Jemena 2026 - 2031 Regulatory Proposal

REVIEW OF PROPOSED EXPENDITURE ON ICT AND CER

Report prepared for:
**AUSTRALIAN ENERGY
REGULATOR (AER)**
August 2025

Figure 2.1: JEN multi-year view of ICT expenditure – direct unescalated expenditure (real \$m, 2026)

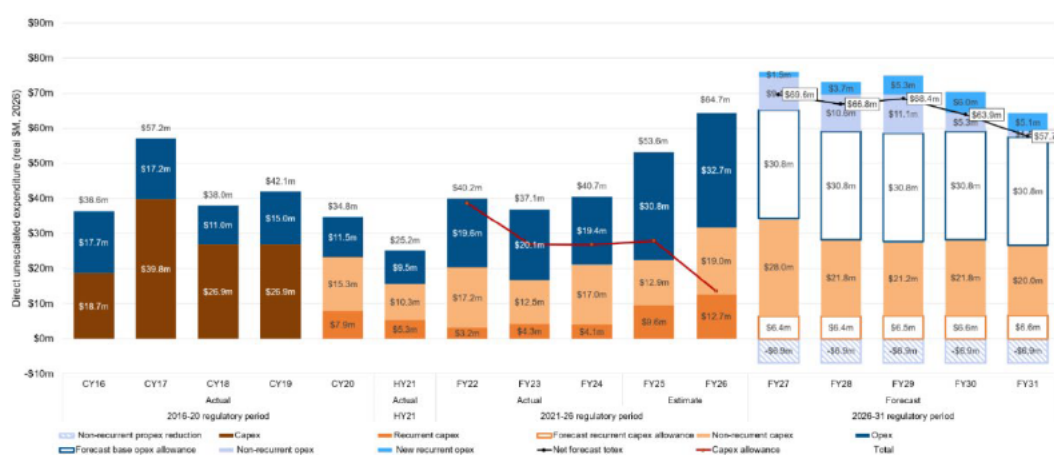
59. We asked Jemena to provide the historical ICT information underlying the graph above, in spreadsheet form. Jemena provided a response; however the historical information did not match with the data on the graph, and its forecast information did not match either with the data on the trend graph or with data in its proposal. While noting this, however, we present the information that Jemena provided in Table 2.3, for the current period. This shows ICT totex (excluding cyber security) of \$217m in the current period, comprising \$107.7m capex and \$110m opex.

Figure 3.3: Recurrent capital expenditure, \$2026, millions

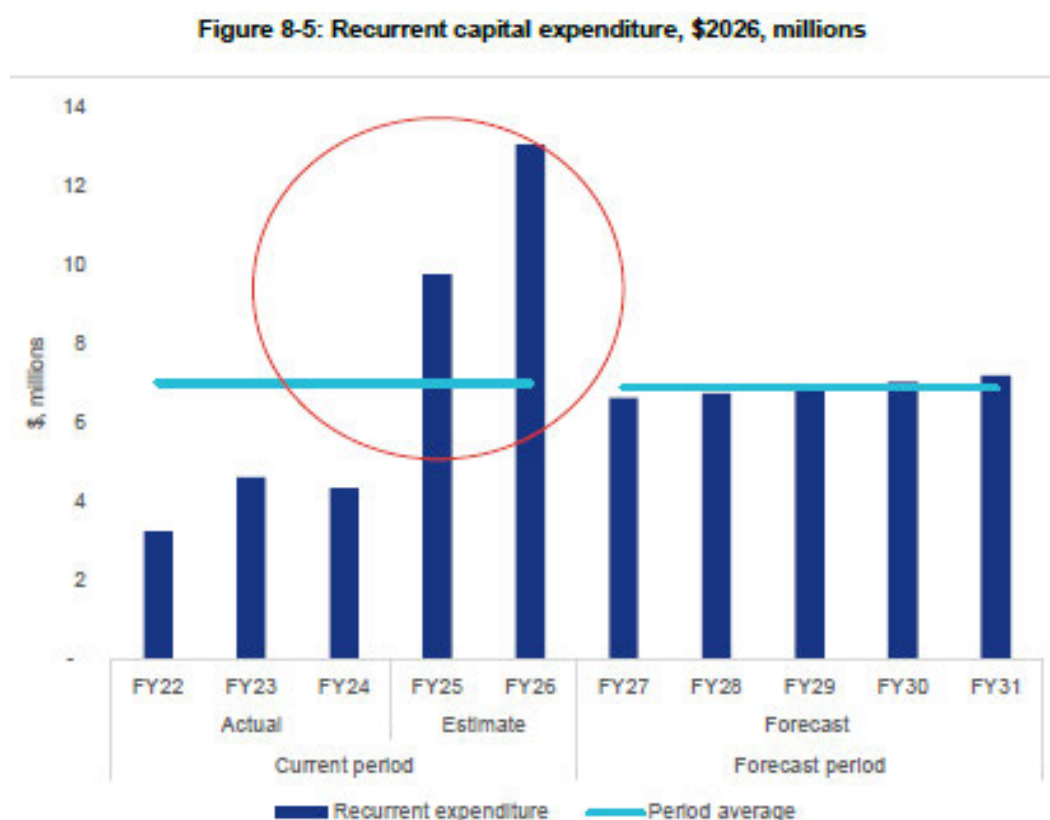
85. Jemena's five-year average is not entirely based on its actual expenditure as it incorporates its forecast expenditure for 2025 and 2026.
86. Figure 3.3 is reproduced from Jemena's capital expenditure proposal and explains how it has derived its five-year base value.

Figure 3.4: Jemena's key resilience tenets

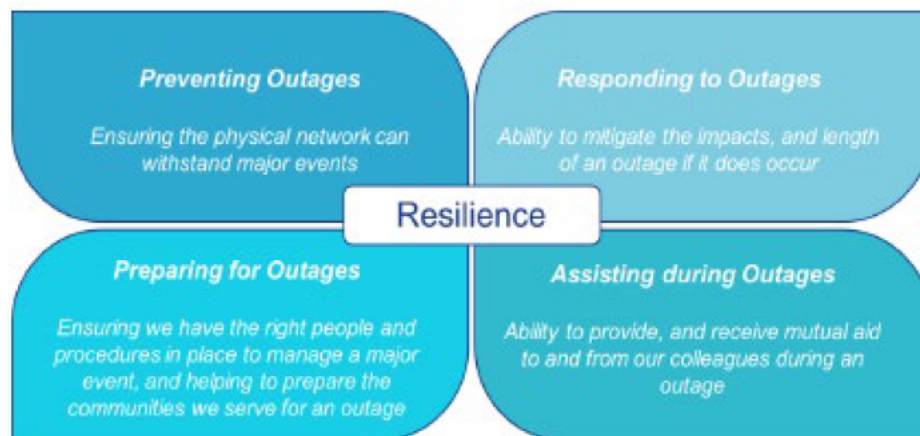
247. We find the wording of this statement confusing, as the investment brief itself is titled 'Outage Preparedness and Response', whereas these sentences seem to imply that responding and assisting are covered by a separate project. However, we infer that the intended meaning of the second sentence is to define what the current project is intended to achieve.
248. This objective can also be inferred from the diagram in Figure 3.4. That is, that the intended objectives are to address the lower left and the two right-hand quadrants in the diagram, i.e. preparing for, responding to and assisting during outages. We assess this further below.

Figure 3.5: Jemena's assumed project implementation timeline

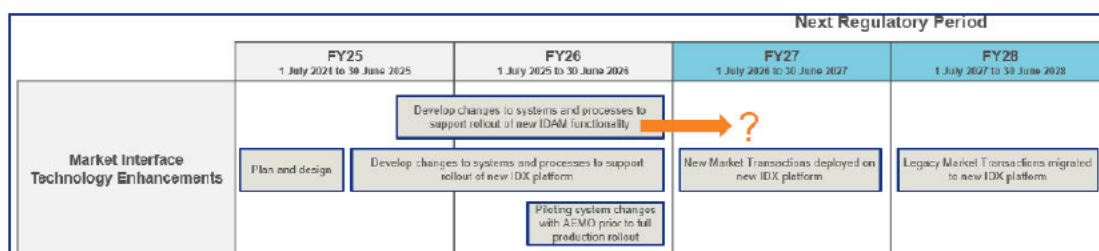
274. Jemena further advised that it had recently been informed that AEMO's MITE procedural changes that had been due in March 2025 would now be provided in November/December 2025 and that a revised timetable for IDAM will be provided in June 2025. While these delays can now be essentially taken as given, Jemena confirmed that the capex that it has proposed for the next regulatory period is based on the Figure 3.5 timetable.

Figure 3.6: Jemena's year on year storage growth (%)

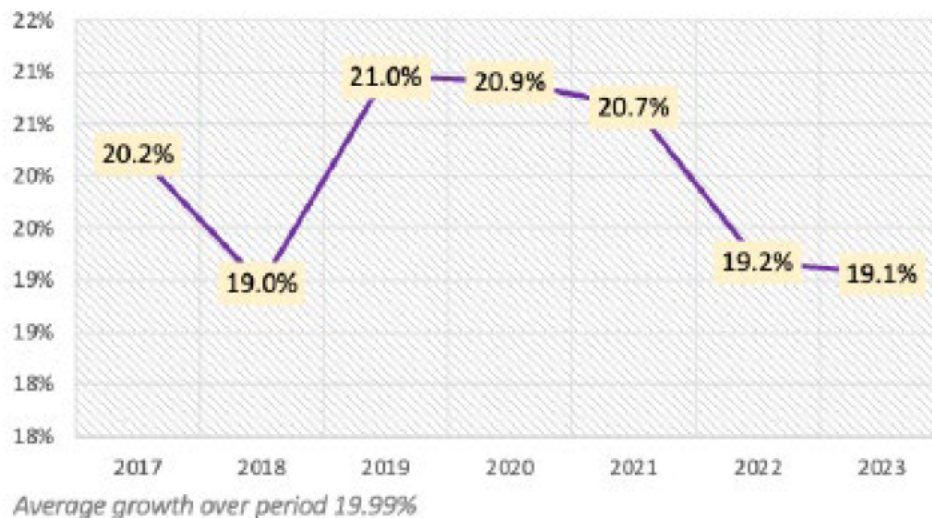
301. Jemena states that it considers that a shift toward cloud computing facilitates efficient ICT capacity growth management. Recognising this, Jemena executed a Cloud Adoption program in 2021 and migrated over 100 applications to [REDACTED] cloud.
302. In its business case Jemena provides evidence of storage growth averaging around 20% per year, as shown in Figure 3.6. However, in estimating its requirements for the next regulatory period, Jemena has adopted a slightly more conservative growth rate of 15% per year and we consider this to be a reasonable assumption.

Figure 4.3: Jemena's timeline for its CER programs

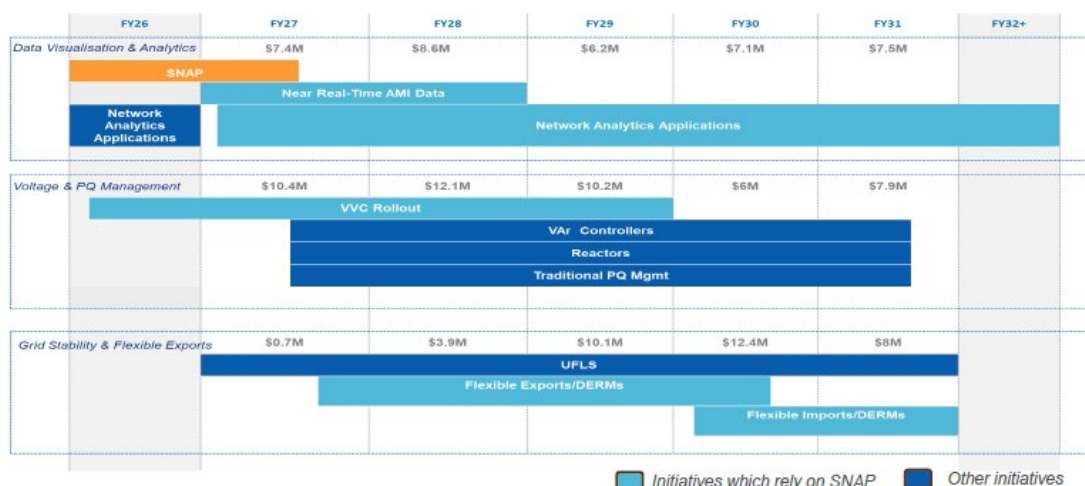
354. The timeline indicates deployment of flexible exports in mid FY30 and flexible imports at the end of FY31, and we consider this in our assessment of its proposed expenditure on flexible services.

Figure 4.8: Jemena’s NPV estimates for each flexible services option - \$’000, 2024

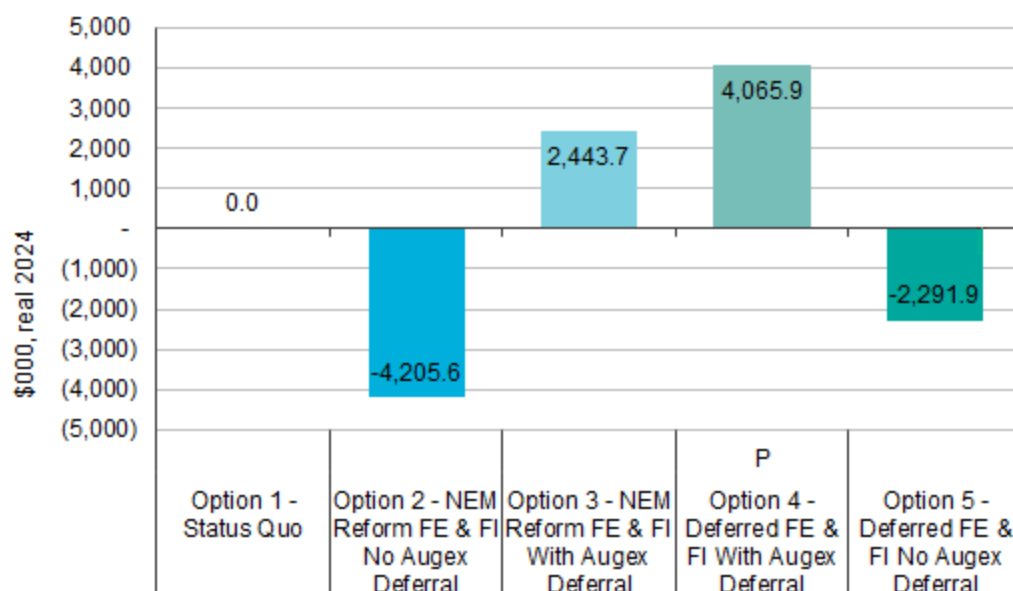
427. As shown in Figure 4.8, the NPV of Jemena’s option 4 is higher than for option 3. Option 4 is the same as option 3 but deferred by two years (i.e. to 2030) showing that Jemena’s ‘deferral’ improves the NPV. We investigated timing further and we find that the optimal timing to deploy flexible services, based on Jemena’s analysis, would be 2032.⁸⁸ In other words, the NPV would be higher still if Jemena deferred implementation by a further 2 years.
428. While this is a direct result from analysis of Jemena’s CBA information, we tend to ‘take this into account’ in our findings rather than assuming that a modelling result alone provides a definitive conclusion on our assessment.

Figure 4.9: Cumulative discounted net benefits of proposed flexible services program - \$m, real 2024

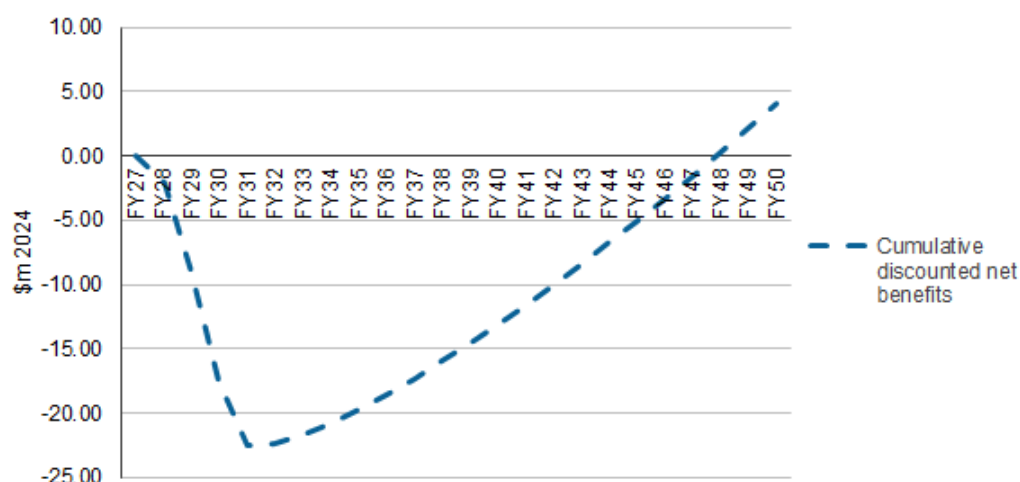
425. Noting that Jemena’s NPV is based on a relatively long assessment (to 2050) yet has a relatively small NPV relative to its proposed capex of \$29.4m, we also investigated how the net present value was ‘earned’ over time.

426. In Figure 4.9 we show the NPV on a cumulative basis. As can be seen there, it is negative until 2048 and achieves the value of +\$4.1m only as a result of assumed benefits in 2048, 2049 and 2050. While the end result is positive (on Jemena’s assumptions) it is not a robust result, given the uncertainties associated with introducing a new service five years from now and operating it for a further 20 years. We observe, for example, that the equivalent analyses that CitiPower, Powercor and United Energy have done are to 2040.

Figure 4.10: Comparison between CitiPower and Jemena's estimated benefits from Flexible Services - \$m real terms⁹⁰

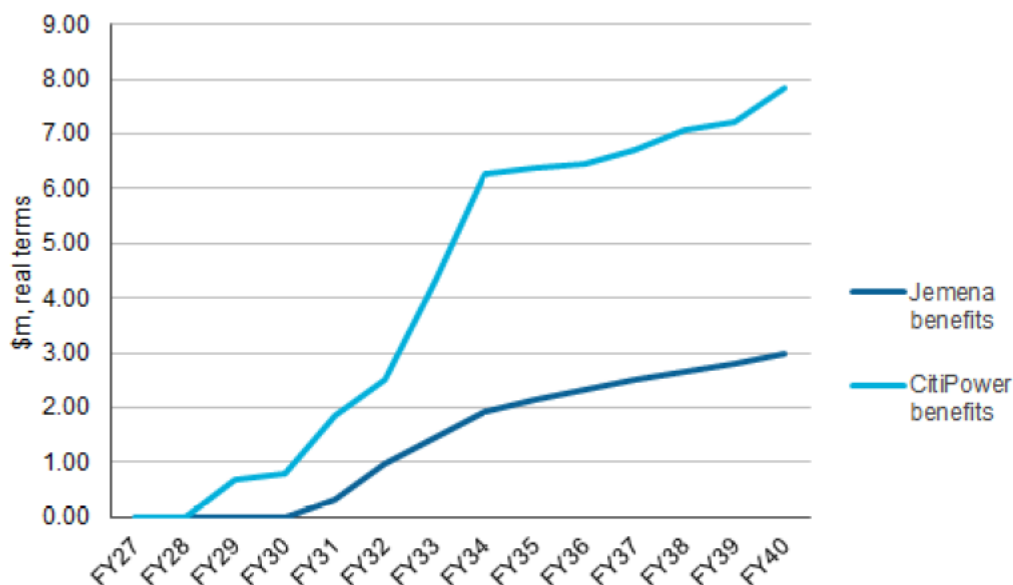
429. In Figure 4.10 we show a comparison between CitiPower’s assessment of benefits from flexible services, and Jemena’s.
430. While CitiPower and Jemena are similar in size,⁸⁹ there are inevitably differences in Jemena’s network relative to CitiPower’s, and we would expect there to be intrinsic reasons why the assessments of benefits differ. Also, Jemena proposes to introduce flexible services around two years later than CitiPower, and which accounts for the lag that is evident on the graph. Nevertheless, the difference in the rate at which benefits are assumed to accrue is stark.

Figure 4.12: Steady-state overvoltage compliance by DNSP

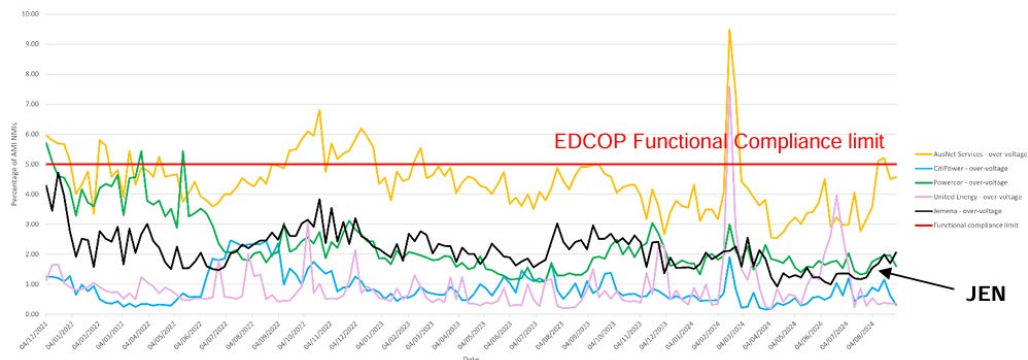
455. Jemena advises that up to 3.9% of its customers experience non-compliant over-voltages (and 3.6% experience non-compliant under-voltages). As shown in Figure 4.12:
- This may have been the case in late 2022 (over-voltage) but the most recent 12 months performance averages around 2% overvoltage, and
 - Jemena's over-voltage performance over the period 2022 -2024 has been well within the statutory 5% limit and Jemena has not provided any updated information to confirm that its performance has deteriorated markedly since.
456. JEN's under-voltage performance is similarly well within the limit (as shown separately in its business case).

Figure 4.13: JEN's increased annual energy consumption due to over-voltages (MWh pa) by ZSS (2023)

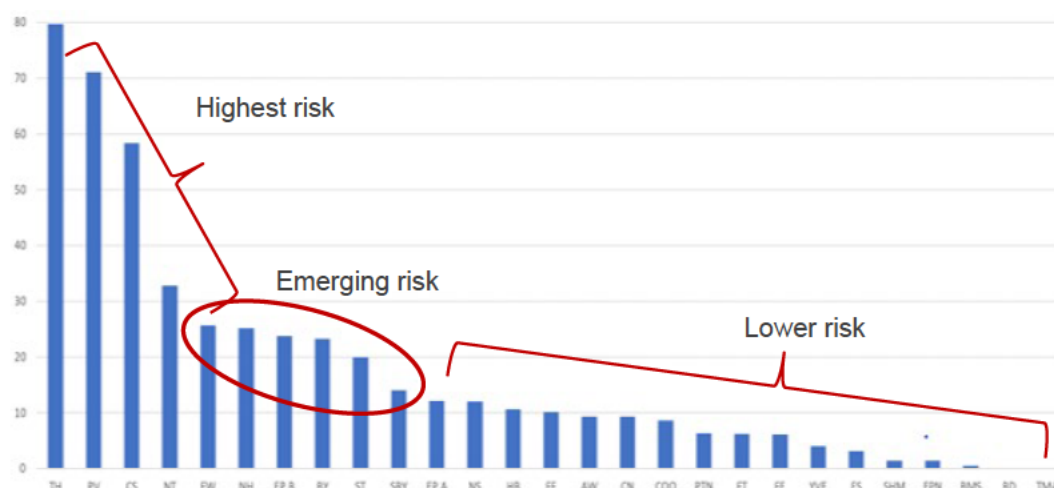
1. Collectively, the graphs confirm that there are material over-voltage regulation risks arising from four to five ZSS now, material risks emerging over the next five or so years at about another eight-ten ZSS, and a lower risk at the remaining 10+ substations. Figure 4.13 shows a defacto over-voltage measurement for JEN's network (at the ZSS level and as measured in 2023) showing 17 substations with relatively low overvoltages.
